## **STAFF REPORT AND RECOMMENDATION TO THE DESIGN COMMISSION**

CASE FILE: LU 21-012886 DZM GW

*Site Upgrades*

**Case Type:** DZM GW – *Design Review with Modifications and Greenway Review*

## SITE AND LANDSCAPE PLAN

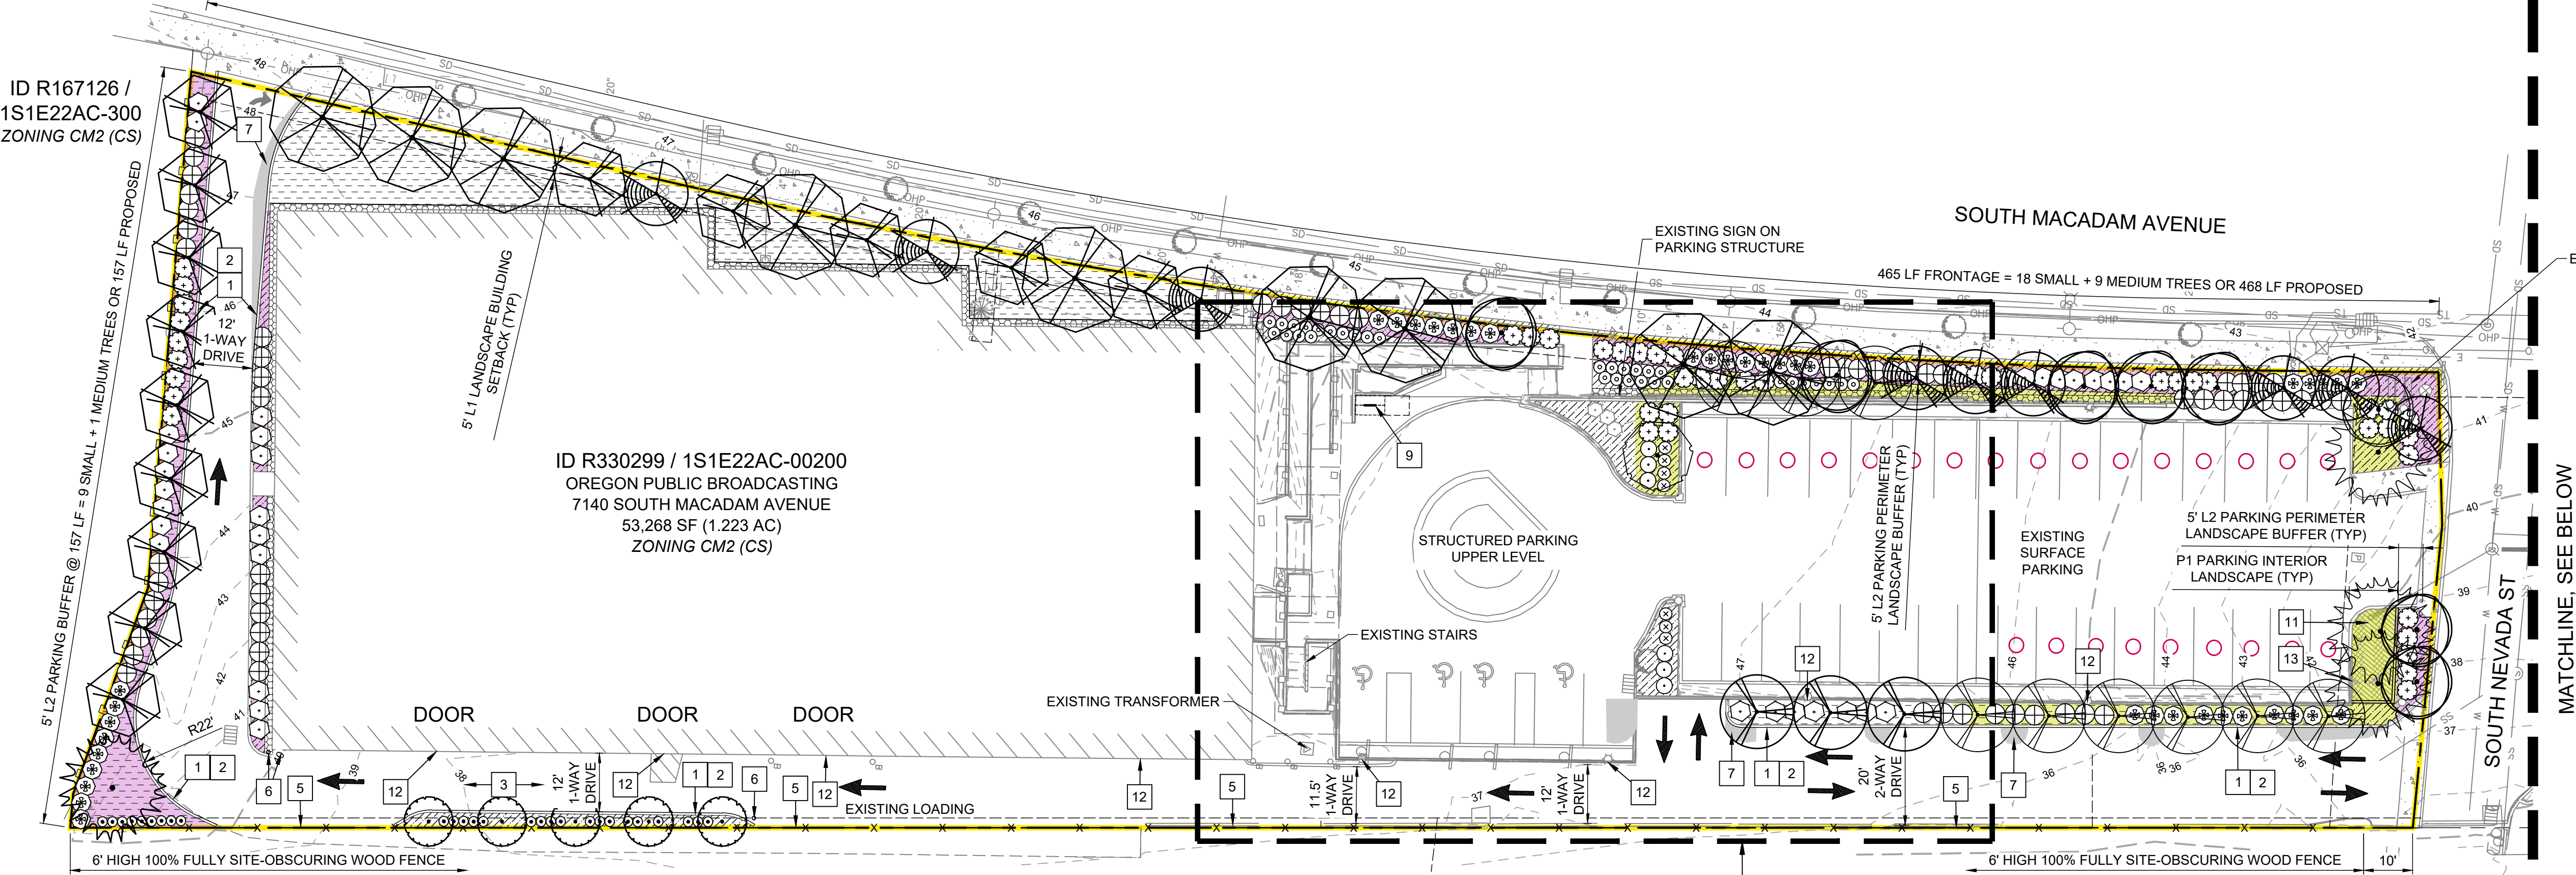
**Findings for 4:** As shown on sheet L3.0 of the plan set, thoughtful and durable landscape plantings are proposed along the perimeter of the parking areas abutting South Macadam Avenue. The layering of shrubs and canopy trees soften the vehicle area and enhance the boulevard's treatment and contribute to the attractiveness of this entrance to the City. The proposed sight-obscuring fencing will also further screen and shield the OPB building and satellite dish and generator area from views from Willamette Park, which serves as an additional pedestrian entrance to the City, and alternative to South Macadam Avenue.

Landscape Plantings & Fence - As shown on sheet L3.0 of the plan set, extensive landscape plantings are proposed along the perimeter of the parking areas abutting South Macadam Avenue and South Nevada Street. Differing uses to the east (Rail right-of-way, Willamette Park, and single-family residential) are proposed to be buffered from the site by a sight-obscuring six-foot wood fence where landscaping treatments are not possible due to site constraints. The layering of shrubs and canopy trees at the perimeter of the structured parking area, in conjunction with the proposed fence and additional trees at the east and south property lines, will soften the visual impact of the existing vehicle areas and enhance the transition between the existing development and adjacent residential areas and public open space.

To facilitate and enhance the proposed buffering of the site the applicant proposes to increase screening at the southeast corner of the site, which is closest to nearby single-family residential. The existing building and parking structure are located at a slight angle to the east property line, resulting in slightly more space between the building and the east property line at the south end of the site than the north end (see L3.0 – Site and Landscape Plan). This wider area provides space for larger plantings while still functioning as an active driveway and loading area.

At the south/southeastern portion of the site, a row of deciduous trees is proposed along the south property line, and an existing mature cherry tree is located at the corner is proposed to be replaced with an evergreen incense cedar. The applicant's landscape architect notes the cherry tree is approaching the end of its typical lifespan and is in poor condition. A neighbor has suggested that evergreen plant material at this location would better achieve the neighbors' desired year-round visual screening from the lights and activity at this location. Therefore, the applicant proposes to replace the older cherry tree with an evergreen tree that addresses the neighbor's request.

Driveway Reconfiguration - An existing driveway runs the length of the east property line behind the structured parking and office building. The driveway has operated as a one-way southbound, with vehicles accessing it from South Nevada street and, upon leaving the bottom level of the structured parking area and loading docks, turning right to continue around the south side of the building. This has resulted in all traffic driving through the site to the area closest to residential neighbors. The driveway exits onto South Macadam Avenue at a location where vehicles can only turn right.

With this proposal, the applicant intends to remove five existing parallel parking spaces between the northern portion of the driveway and the structured parking. The removed spaces will facilitate the construction of the new planters, to provide perimeter landscape screening and stormwater treatment, if feasible,

for the structured parking. The planters are proposed to hold nine trees, as well as evergreen shrubs and groundcover to meet the perimeter landscaping requirements.

The expanded driveway width at the northern portion of the parcel will also facilitate converting the one-way drive to a two-way direction for this portion, which allows all vehicles existing the structured parking to turn left out of the bottom level of parking and then exit the site via South Nevada. This results in reducing the vehicle traffic passing near the residential neighbors and allows exiting vehicles to leave the site at a location where cars can turn left or right onto South Macadam.

While all personal vehicles will now exit the site via South Nevada, all maintenance and delivery vehicles that utilize the loading area will continue to exit the site near the residential neighbors. To mitigate the ongoing vehicle impacts on the residential neighbors, the applicant proposes that a minimum of 5 trees shall be planted along the east property line behind the OPB building, interior to the proposed wood fence, and the trees shall comply with the native plant requirement of the Willamette Greenway Plan. Trees will be located as appropriate to ensure no conflicts with loading operations and to allow for adequate clearance for vehicles turning around the SE building corner. Bollards or other protective elements may be installed to ensure separation between trees and vehicles.

the trash area, and the new sight-obscuring fence to the east may provide sufficient screening to meet the Title 33 standards, permit approval shall necessitate additional screening on the north side of the trash and recycling area to fully screen it from the South Nevada right-of-way.
